In the matter of an application for approvals by New Zealand Transport Agency Waka Kotahi (**NZTA**) to develop a rapid transit link, associated infrastructure and connections between Brigham Creek and Auckland City Centre (**NWRT Project**).

Engineering Statement by Steven Rankin on behalf of Stride  
Holdings Limited in relation to the NWRT Project by NZTA

**Multi-Criteria Analysis**  
**D085 Alignment of busway through Fred Taylor Interchange**

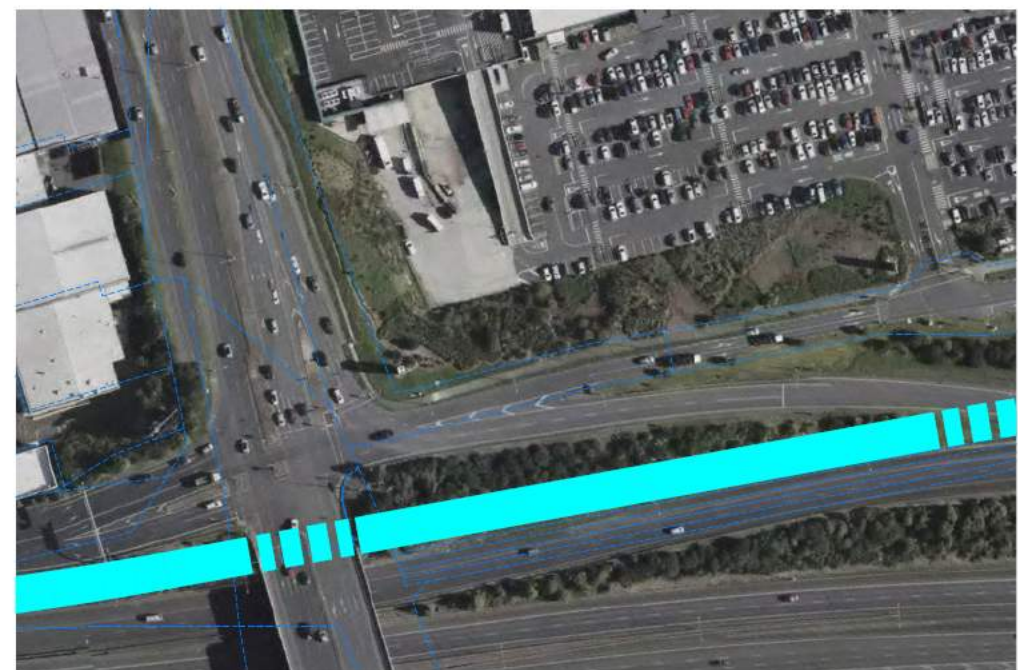
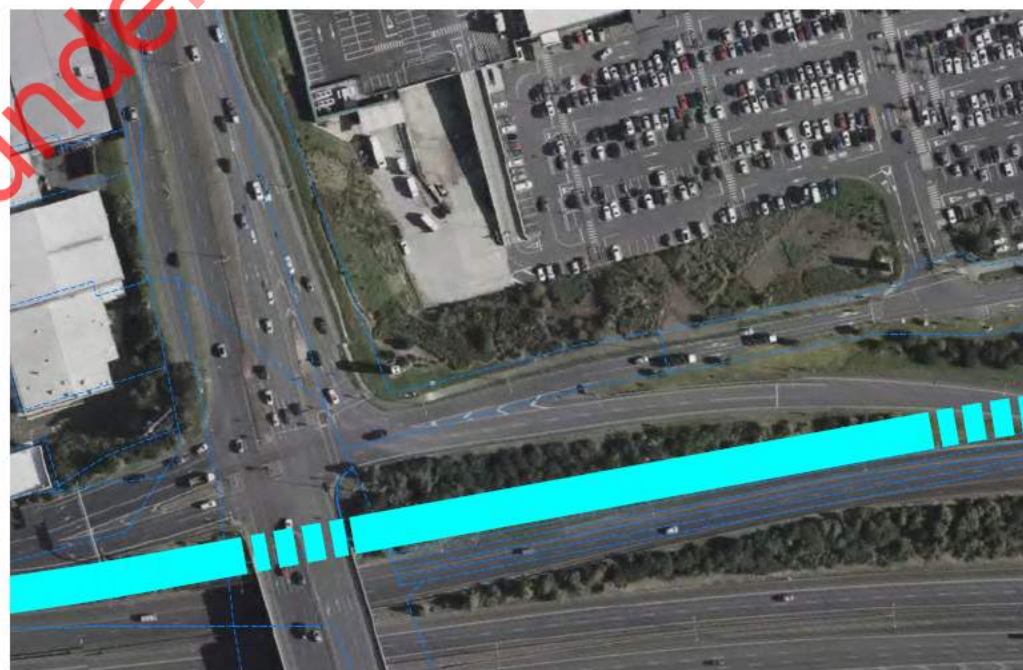
18. It is unclear how this point is scored when Option 7 relies on working outside the existing corridor and requires realignment of Gunton Drive (which is not mentioned for Option 7 in the MCA extract but is noted for Option 13.

19. In my view, when the realignment of Gunton Drive and the SH18 onramp are properly accounted for, Option 7 should score -1 on this criterion; so worse than Option 13.

22. I expect the relocation of the high-voltage substation for Option 7 introduces significant additional complexity and risk that is not fully reflected in the -2 score. In contrast, Option 3 avoids substation relocation entirely.

23. Option 3 has been scored -3 whereas it doesn't impact the substation, however it shares the need for an underpass below Hobsonville Road rather than Fred Taylor Drive.

24. I acknowledge the underpass below Hobsonville Road is more complex than the Fred Taylor option with the working space and the existing structure. I would challenge that Option 7 and Option 3, when the substation is considered, likely present the same level of complexity.

25. Further, I think Option 7 and Option 3 have more technical risk than Option 13 and therefore the scoring should acknowledge a difference. I do not agree with the current scoring where Option 7 and Option 13 has been assigned the same score of -2, I consider that Option 7 reduces from -2 to -3 to align with Option 3.

26. The Value for Money criterion does not appear to adequately consider the full cost of land acquisition, business disruption, or loss of future development potential on private land.

27. I do not think the scoring accurately reflects the severity of the property impacts between each option. All options are scored -2 or -3, a single point of difference seems deficient to quantify the differences between each option.
28. I would expect Option 13 to score better than Option 7, and Option 3 to score better than Option 13 (noting the effects of an overpass on property).
29. Making the adjustments outlined above, in my opinion the relative ranking of the options changes. My revised scoring is shown in Table 2 following. These adjustments suggest that Option 3 performs at least as well as Option 13, and in my view better than Option 7 when property impacts and optimisation of the existing corridor are given appropriate weight.
